I am speaking on behalf of both Cyclox and Oxfordshire Liveable Streets.

This is a case where funding deadlines have forced both construction and planning to happen too fast for proper consultation or coproduction. This crossing was originally planned as a zebra crossing but is being changed to a parallel crossing at the very last moment.

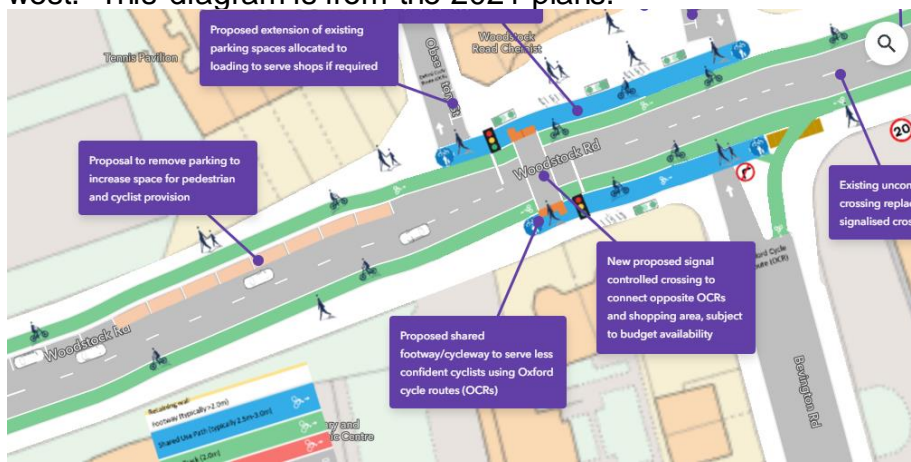
In general, parallel crossings should be used to connect cycle tracks on either side of the road, not cycle lanes, as direct use of crossings from cycle lanes will be unpredictable and dangerous. Imagine someone cycling north along Woodstock Rd wanting to turn right onto Bevington Rd. The current plans provide an island protected central waiting space (with a cycle symbol and turning arrow). A parallel crossing would create a second option, turning out of the cycle lane onto the crossing, and then either cycling on the footway to get to Bevington Rd or cycling contraflow on the carriageway cycle lane. (It may be argued this is not the intended use of the parallel crossing, but what then is the purpose of having it at all?)

Turning directly out of the cycle lane onto the crossing is not safe. People driving are not going to expect people cycling on the left of the road to turn right across them. And if people cycling stop to wait for a gap in the traffic, it will look like they are stopping to let a pedestrian cross rather than trying to use the crossing.

So we think this should be left as a zebra crossing. If it is to be made into a parallel crossing, then it needs to be accompanied by measures to allow it to be legally used - most importantly support for contraflow cycling connecting it with Bevington Rd and Observatory St.

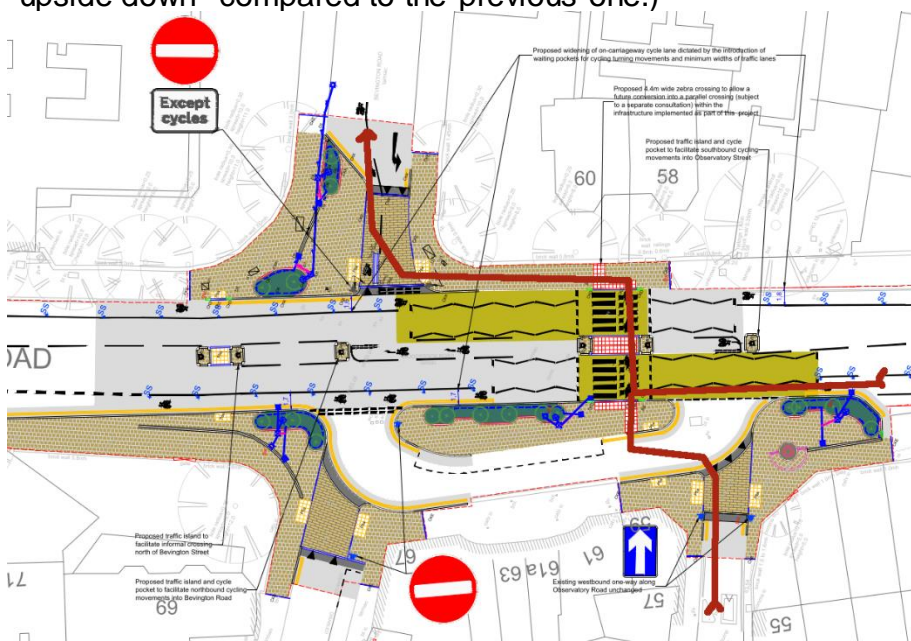
The problem is that, because of this, the features that would allow proper utilisation of a parallel crossing are missing. This can be seen by looking at the plans for Woodstock Rd created in 2021, which had a toucan crossing in a similar location. Those plans had provision for contra-flow cycling, to allow people to cycle from the crossing to Bevington Rd on the east side and Observatory Rd on the west. This diagram is from the 2021 plans.

Without that, this crossing will encourage people to cycle on footways that have no cycle tracks marked to authorise cycling or to warn pedestrians to expect people cycling. There is also nothing at the Bevington Rd exit onto Woodstock Rd to alert drivers to the possibility of people cycling approaching from their left. This diagram shows the design of the current scheme, with one of the potentially dangerous movements, cycling from Observatory St to Bevington Rd. (Note that this diagram is "upside down" compared to the previous one.)
